**APPROVING THE PROPOSED SITE PLAN AND ARCHITECTURAL REVIEW MODIFICATIONS (PA-2020-055)
PARKING AND RELATED EXTERIOR CHANGES TO THE 400 E. 5TH AVENUE PARKING GARAGE APPROVED AS
PART OF THE CITY-OWNED DOWNTOWN AFFORDABLE HOUSING AND PARKING GARAGE SITES PROJECT (PA-
2019-033), AND THE AMENDED CONDITIONS OF APPROVAL**

DOWNTOWN SAN MATEO PARKING STRUCTURE

REVISION TO ENTITLEMENT ITEMS

UNIVERSAL STALL STANDARD

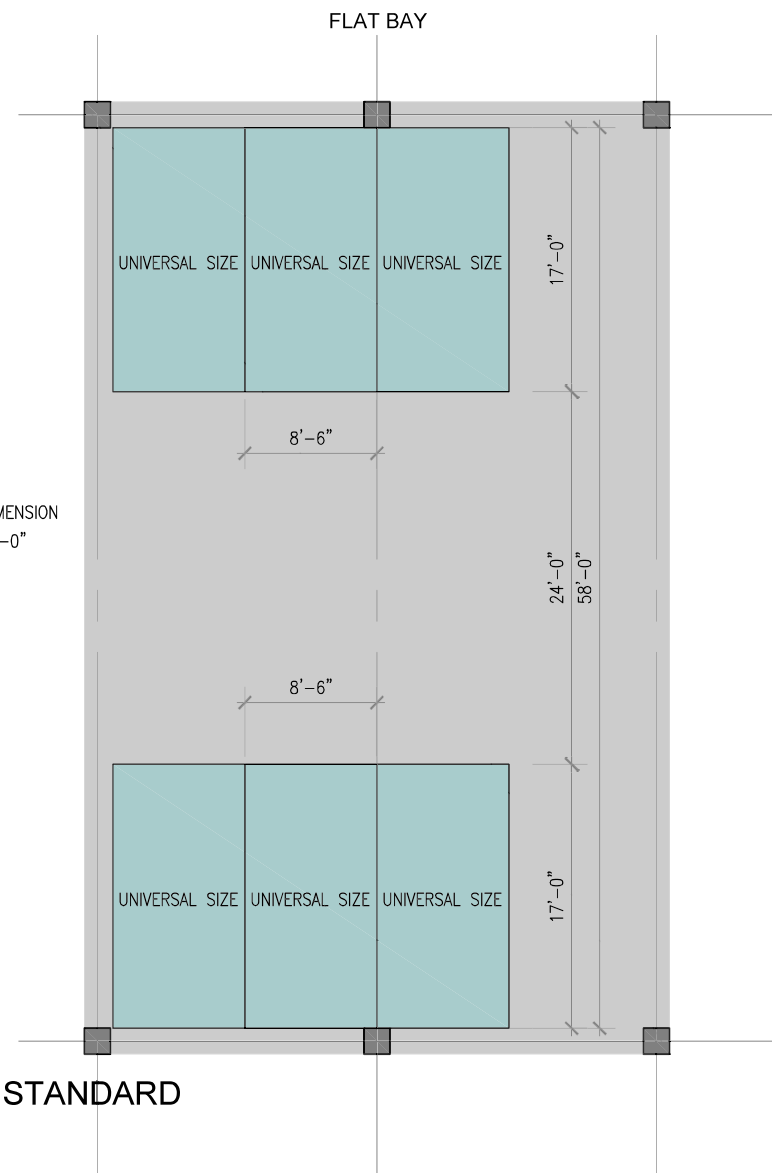
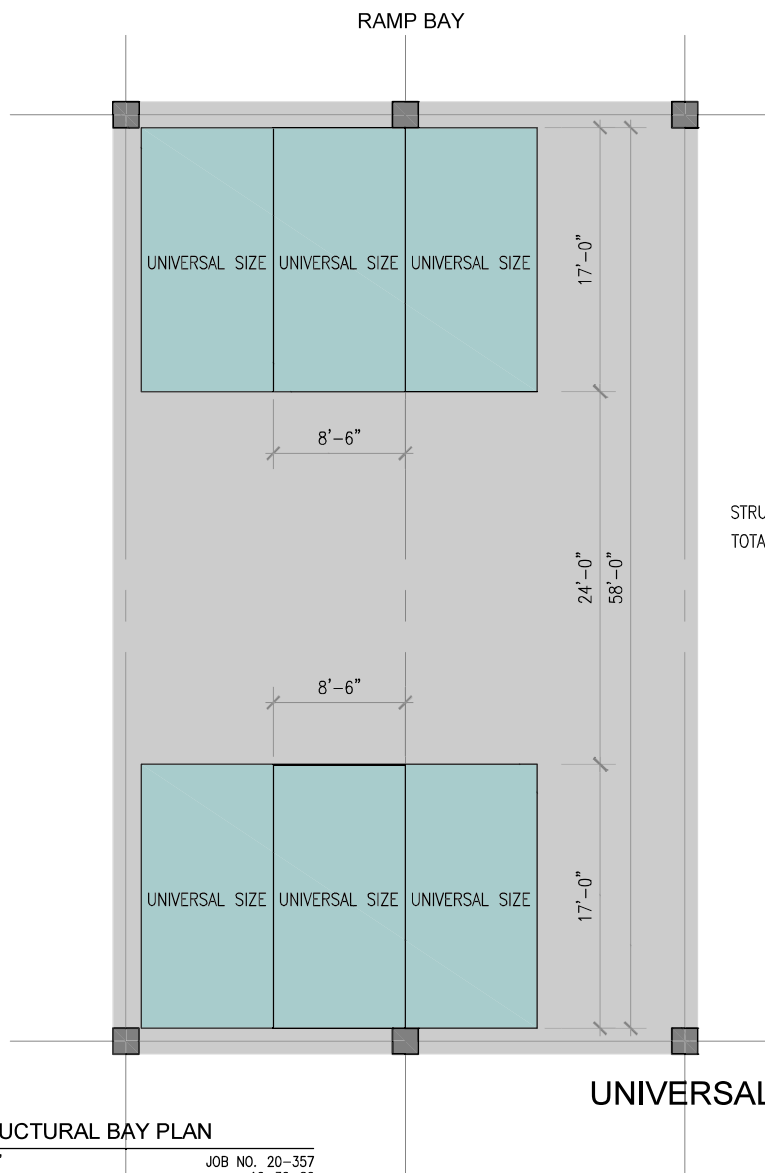
1. STALL STANDARDS
UNIVERSAL STALL APPROACH
2. SIGHT TRIANGLE AND GARAGE SET BACK
24' DRIVE AISLE PROVIDED
3. CIVIL SITE AND UTILITY UPDATES
4. ADA STALL DISTRIBUTION
GROUND & FIFTH LEVEL ONLY
5. STRUCTURAL FRAMING
MOMENT FRAME SYSTEM DESIGN REQUIREMENTS
6. PEDESTRIAN EGRESS PASSAGEWAY
SECOND LEVEL FOLLOWING THE SLOPE TO GRADE
7. EXTERIOR BACK FLOW PREVENTION

PROPOSED BUILDING SECTIONS

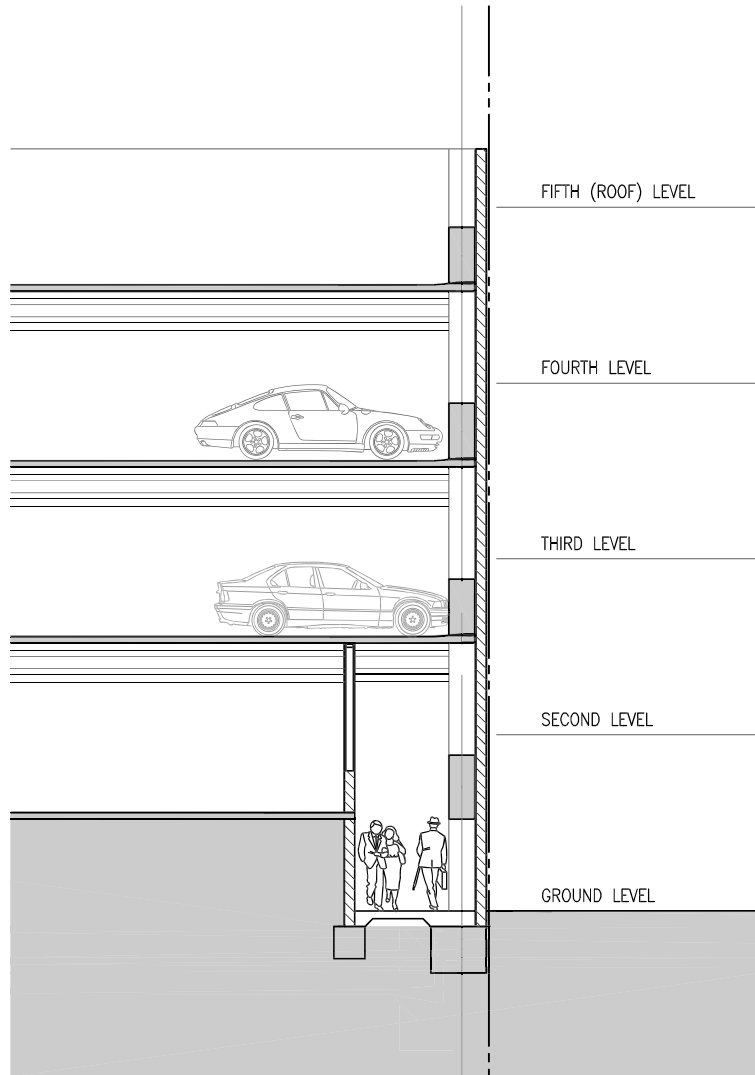
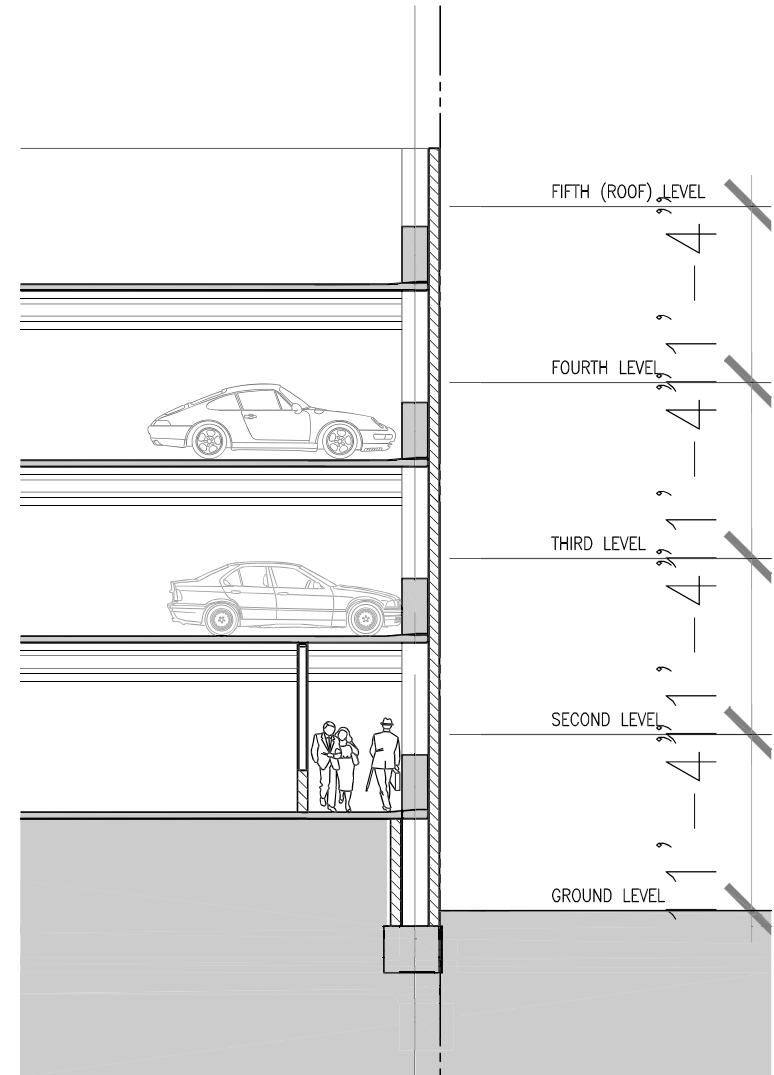
BY ELIMINATING THE INTERIOR SHEAR WALLS, STRUCTURALLY, WE NEED ALL SLABS TO "ENGAGE" THE PERIMETER LATERAL MOMENT FRAMES.

NOTE:
BY ELIMINATING THE INTERIOR SHEAR WALLS,
WE NEED ALL THE SLABS TO 'ENGAGE' THE
PERIMETER LATERAL MOMENT FRAME ELEMENTS

BY ELIMINATING THE INTERIOR SHEAR WALLS, STRUCTURALLY, WE NEED
ADD AN ADDITIONAL COLUMN AT THE STAIR CORNER TO COMPLETE THE
MOMENT FRAME SYSTEM DESIGN.
